HARTZELL PROPELLER INC.
SERVICE BULLETIN
TRANSMITTAL SHEET
HC-SB-61-392

108298 Cylinder Bushing and 108346 Hub Bushing

February 23, 2022

This page transmits a revision to Service Bulletin HC-SB-61-392.

Hub Modification
Figure 9, page 1 of 2

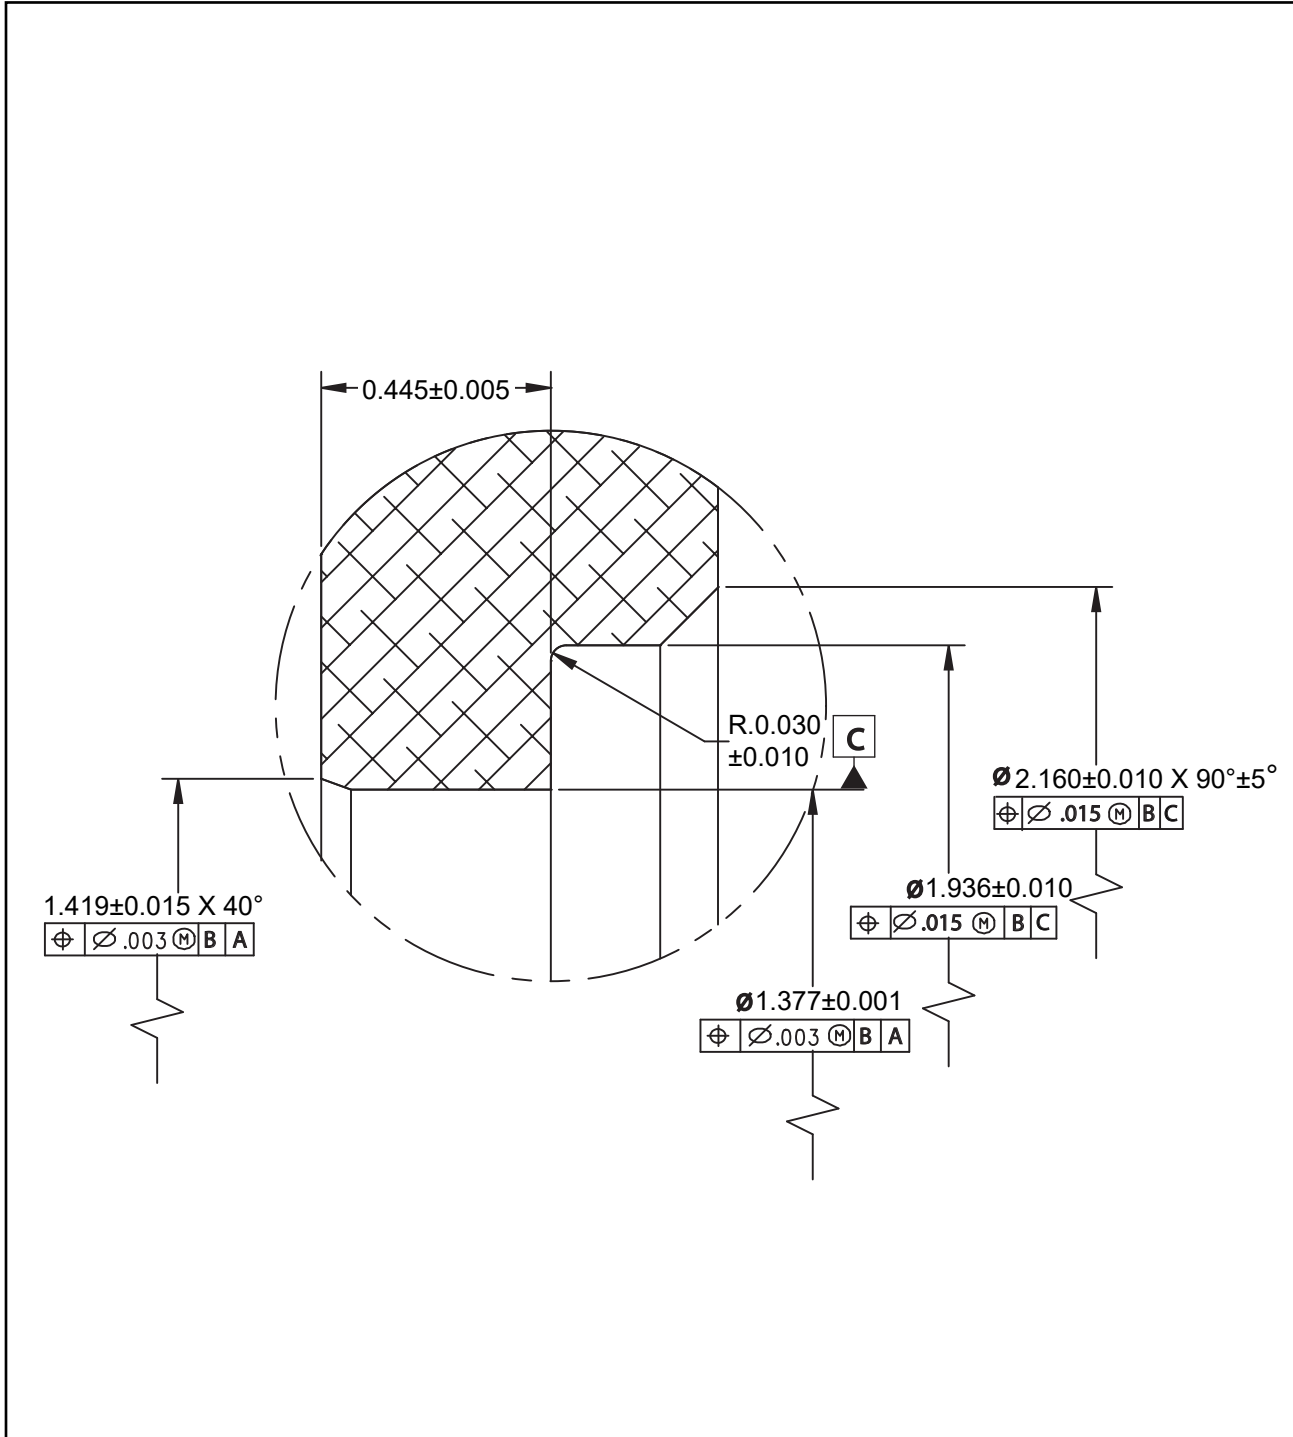
- (1) Remove the bonded A-3789() hub bushing in accordance with the applicable instructions in the Aluminum Hub Overhaul chapter of Hartzell Propeller Inc. Standard Practices Manual 202A (61-01-02).
- (2) Machine the propeller hub in accordance with Figure 9.
 - (a) Remove any burrs.
 - (b) Machined surfaces must have a surface finish of at least 63 micro inches (1.6 micro meters).
 - (c) Apply chemical conversion coating to the machined area in accordance with the Chromic Acid Anodizing chapter of Hartzell Propeller Inc. Standard Practices Manual 202A (61-01-02).
